July 25, 2025

ADDENDUM NO. 2

Re: Outparcel 25B
Creekside Town Center
323 Creekside Crossing
New Braunfels, Texas 78130
Project No. 24051

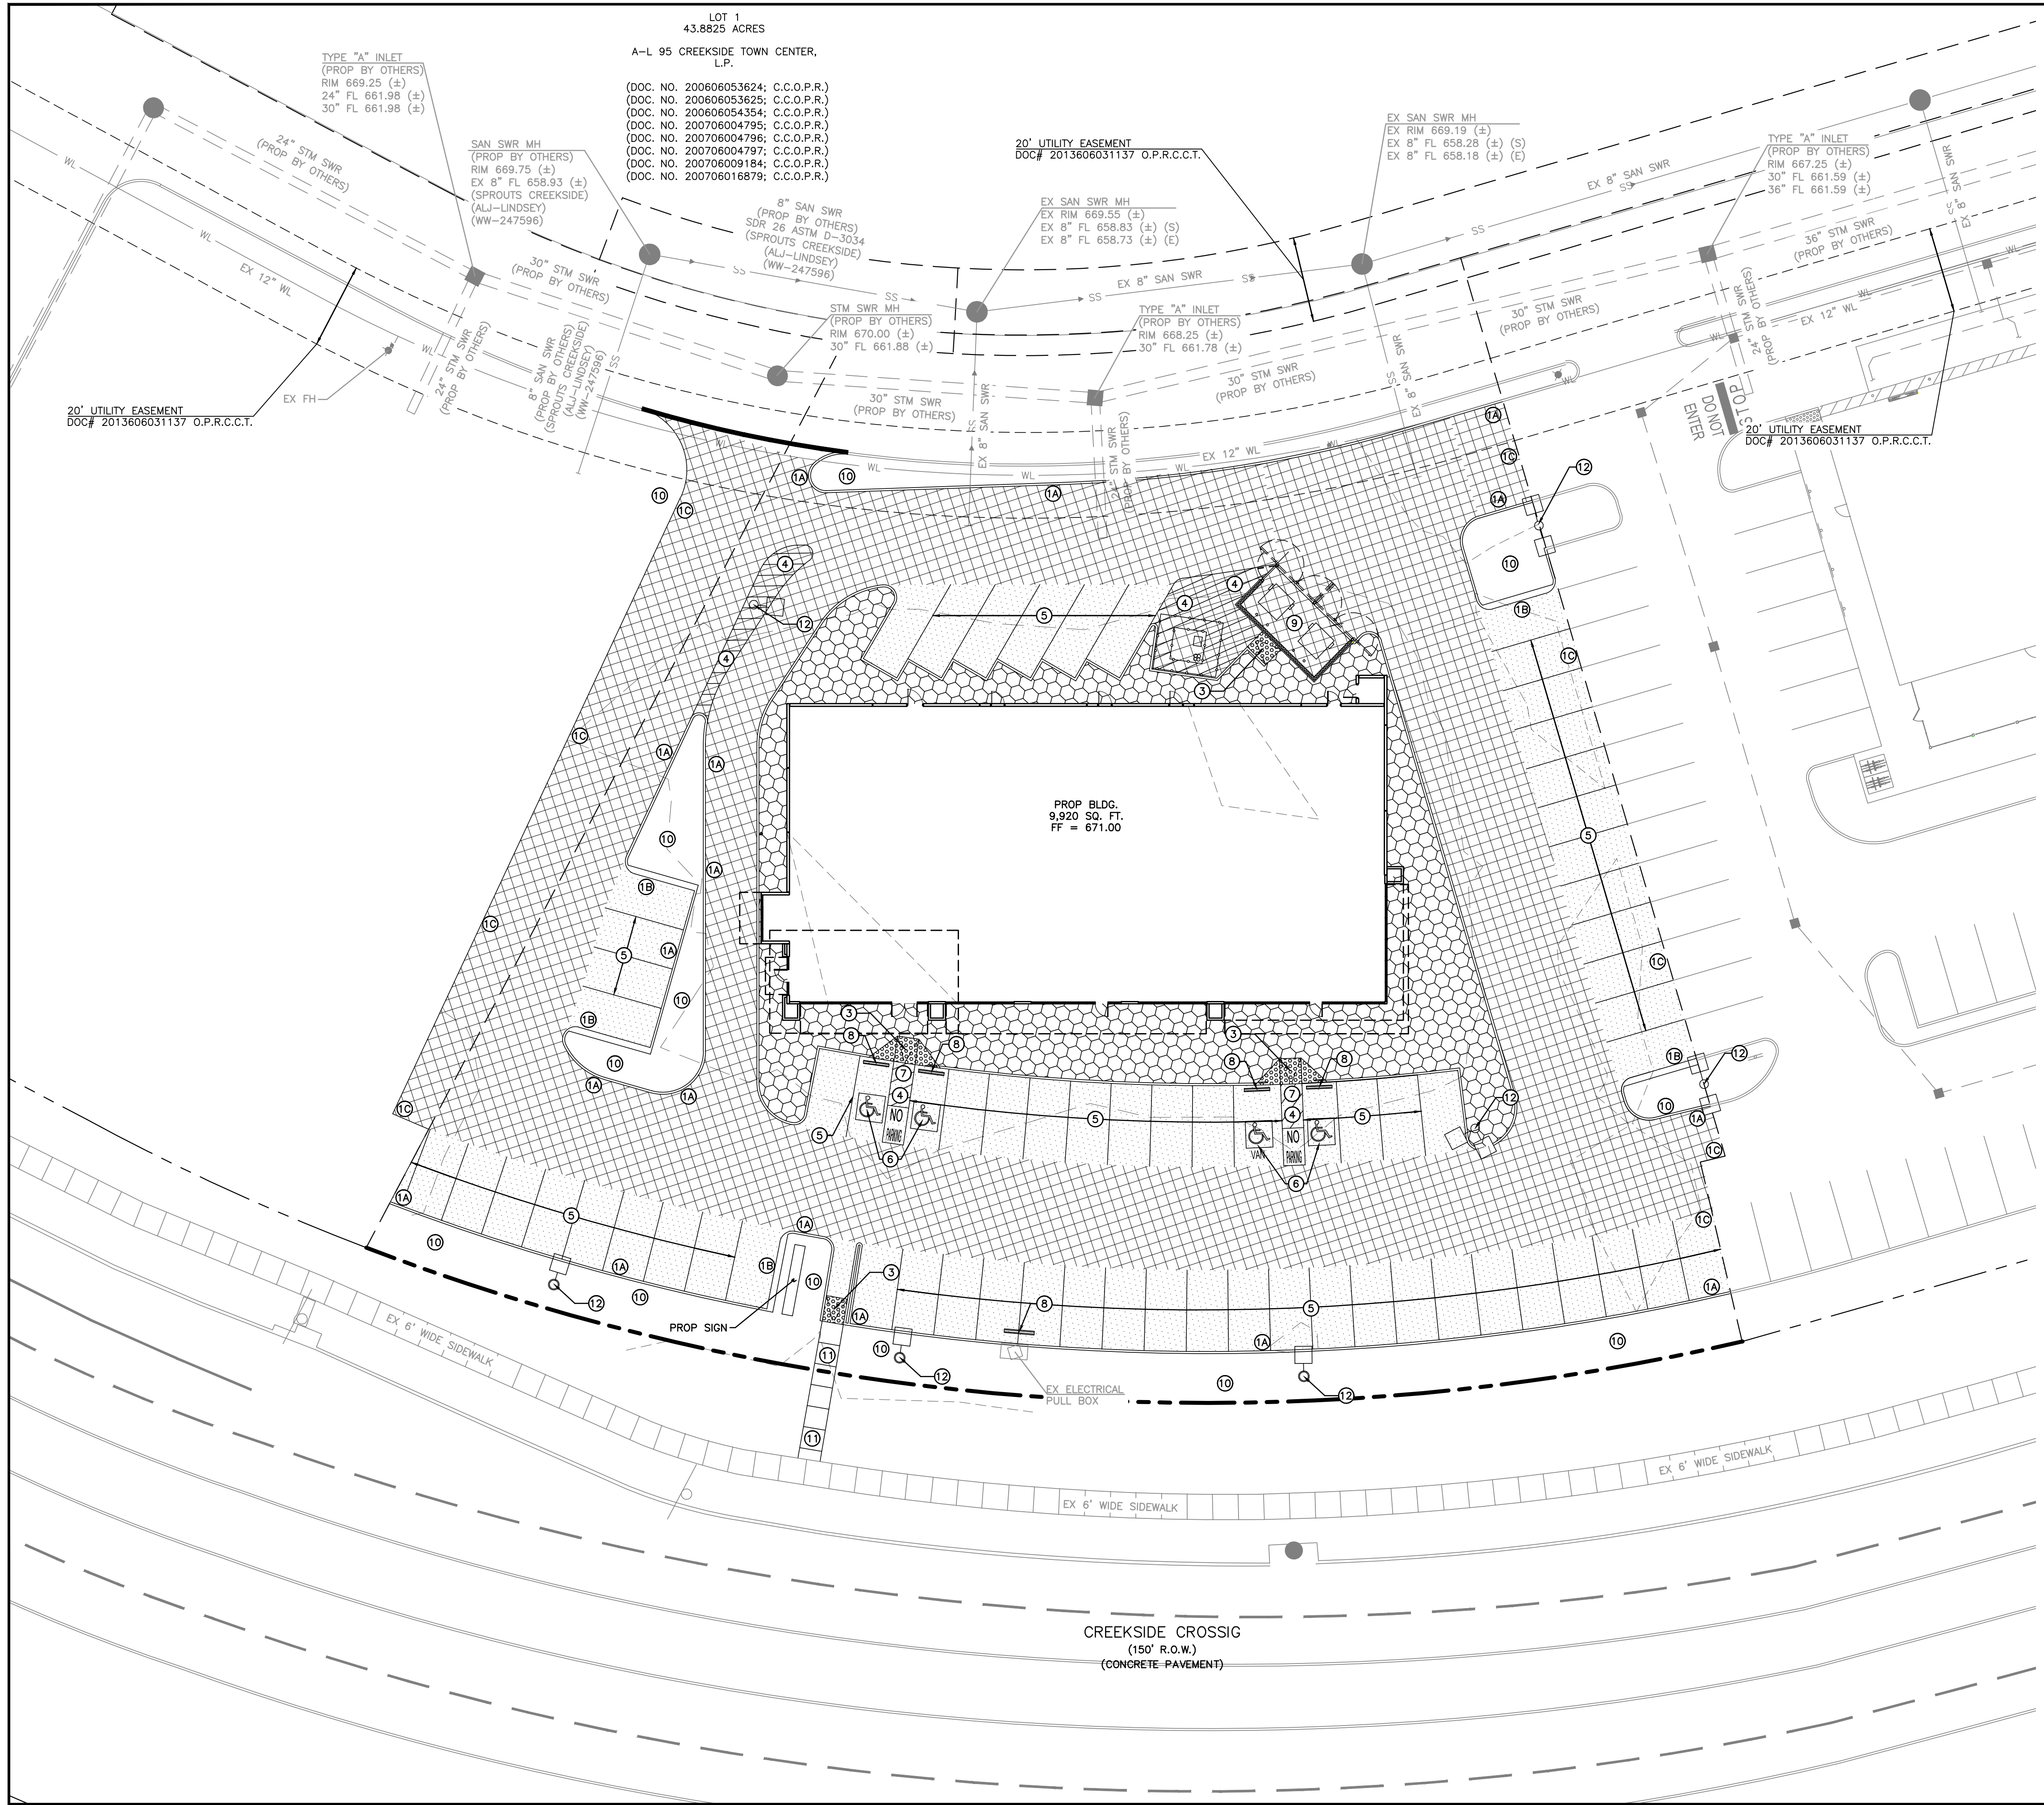
1. Paving plan has been updated per the Geotech Report. Light duty pavement is 5.5" thick and heavy-duty pavement is 6.5" thick. The minimum concrete strength is 4,000 PSI at 28 days, and the paving sections are No. 3's @ 18".
2. Building perimeter sidewalk should be a minimum of 4.5" thick and have a minimum strength of 3,500 PSI @ 28 days
3. Per Sheet A1.0, please provide a 5'-0" slab leave-out across the rear of the building
4. Per Sheet AS1.0, please provide bollards in front of the electrical pull boxes
5. The exterior face of Panel P4 will be clad in metal panels similar to Panels P2 and P3
6. Note 10 on Sheet A1.1 refers to the roof-side face of the concrete panels. Paint is not required where the rear of the parapet is metal panel.

- PROPOSED 5.5" THICK LIGHT DUTY CONCRETE PAVEMENT WITH STABILIZED SUBGRADE (SEE NOTE 2 BELOW)
 - PROPOSED 6.5" THICK HEAVY DUTY CONCRETE PAVEMENT WITH STABILIZED SUBGRADE (SEE NOTE 2 BELOW)
